Access Compliance Report

Public Rights-of-Way

Intersection ID: 12489	Main Street: CHESTNUT_AV	Cross Street: NASSAU_BV	Location: SE
ADA ID: A7D720221FD6	Ramp Type: BlendTrans1	Initial Pass/Fail: Fail	Overall Compliance: No
		Severity Score: 10

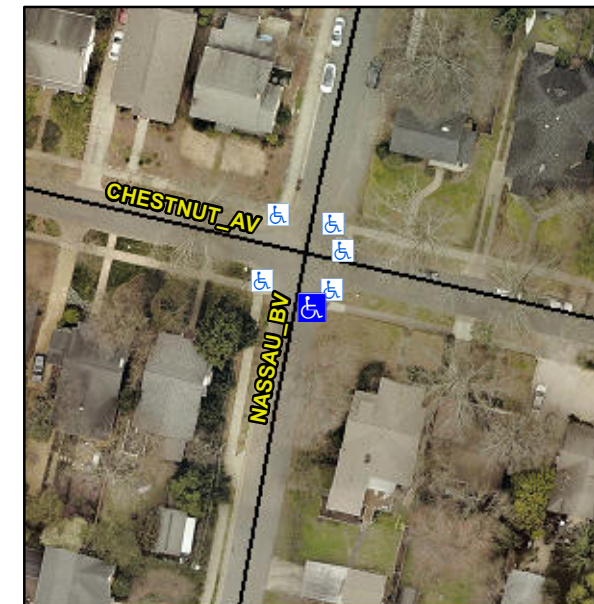
Not Found, R304.5.1, R304.5.3

Compliance	Description	Data	Compliance	Description	Data
N/A	Ramp Length (in)	33.0	Yes	BlendTrans Slope (%)	4.7
No	Ramp Width (in)	36.0	No	BlendTrans XSlope (%)	3.5
N/A	Flare Type LT	N/A	N/A	Flare Type RT	N/A
N/A	Flare Slope LT (%)	N/A	N/A	Flare Slope RT (%)	N/A
N/A	Flare Traversable LT?	N/A	N/A	Flare Traversable RT?	N/A
N/A	Landing Length (in)	N/A	N/A	DWS Provided?	N/A
N/A	Landing Width (in)	N/A	N/A	DWS Contrast?	N/A
N/A	Landing Slope (%)	N/A	N/A	DWS Length (in)	N/A
N/A	Landing X Slope (%)	N/A	N/A	DWS Full Width?	N/A
N/A	Landing Curb? (Y/N)	N/A	N/A	DWS Offset (in)	N/A
N/A	Shared Landing?	N/A			
N/A	Gutter Ponding?	N/A	N/A	Gutter Slope (%)	N/A
N/A	Gutter Lip Ht (in)	0.5	N/A	Gutter X Slope (%)	N/A
N/A	Painted X Walk1?	No	N/A	Painted X Walk2?	N/A
	X Walk 1 Direction	To W		X Walk 2 Direction	N/A
	X Walk 1 Width (in)	N/A		X Walk 2 Width (in)	N/A
	X Walk 1 Slope (%)	3.3		X Walk 2 Slope (%)	N/A
	X Walk 1 X Slope (%)	3.5		X Walk 2 X Slope (%)	N/A

N/A	Ramp inside XWalk1?	N/A	N/A	Ramp inside XWalk2?	N/A
	Road Slope (%)	3.5		Clear Space?	N/A
	Road X Slope (%)	3.3	N/A	Clear Space to XWalk (in)	N/A
N/A	Any Obstructions?	N/A	N/A	Storm Grate/Utility Hazard?	N/A
	Obstruction Type			Storm Grate/Utility Type	
		N/A			N/A
			Yes	Surface Condition? (G/P)	Good
			No	Curb Slope (%)	5.3

Remove & Replace Curb Ramp With Two New Directional Ramps or Equivalent.
